TPL MARK UP  
05.02.2024

PROPOSED OPTION FOR TEMPORARY SURFACE WATER DRAINAGE STRATEGY FOR CONSTRUCTION PHASE

project:  
Care Home Development  
Thomas Street, Lindley  
Huddersfield

drawing title:  
Proposed Drainage Layout

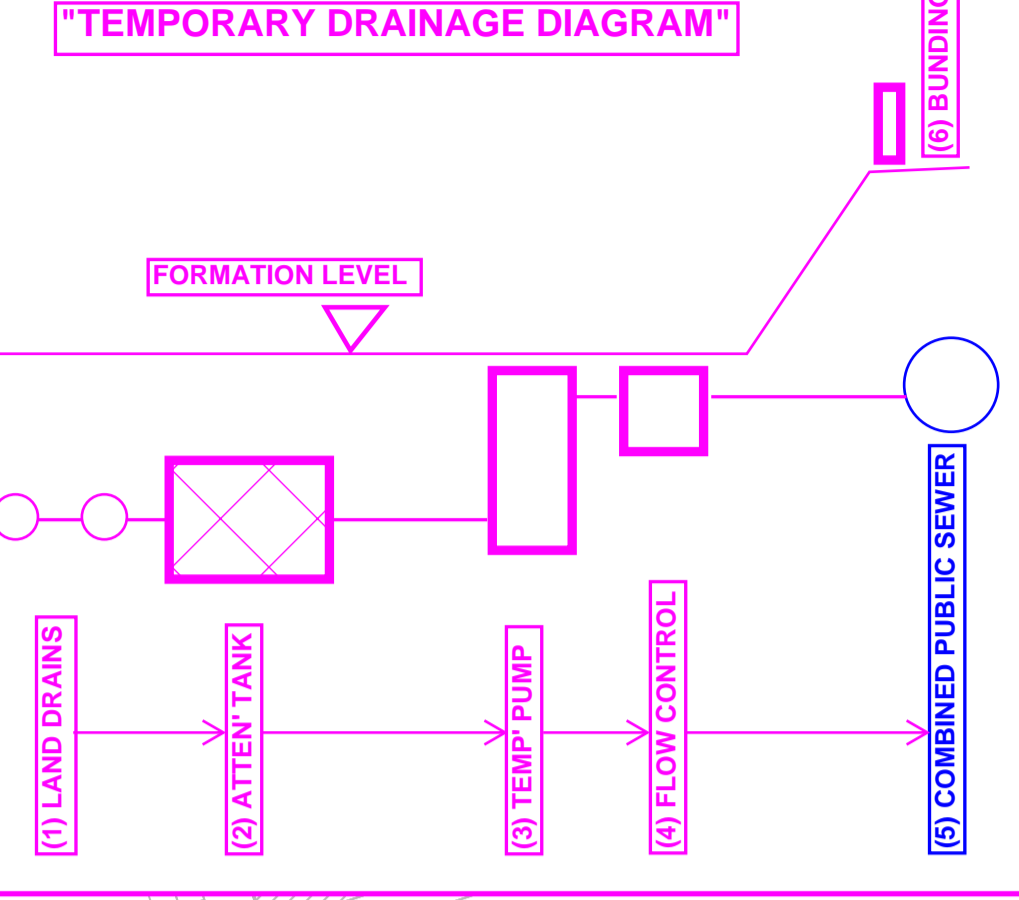
ITEM 2: TEMPORARY BUNDING TO CONSTRUCTION SITE PERIMETER, TO PREVENT SURFACE WATER FLOW OUT OF SITE. (LOCATION TO BE SAME AS SITE BOUNDARY & WHERE REQUIRED.)

ITEM 2: TEMPORARY ATTENUATION TANK TO STORE WATER FROM LAND DRAINS FOR CONSTRUCTION PHASE. INSTALLED AT A LEVEL BELOW FORMATION LEVEL

ITEM 2: LAND DRAINS INSTALLED BELOW FORMATION LEVEL TO CAPTURE WALL SURFACE WATER ACROSS CONSTRUCTION SITE

ITEM 4: TEMPORARY SURFACE WATER PUMP TO PUMP WATER UP TO CORRECT LEVEL FOR DISCHARGE INTO FLOW CONTROL VIA HYDRO BREAK

ITEM 2: 7 x 7m CONCRETE CRANE MAT
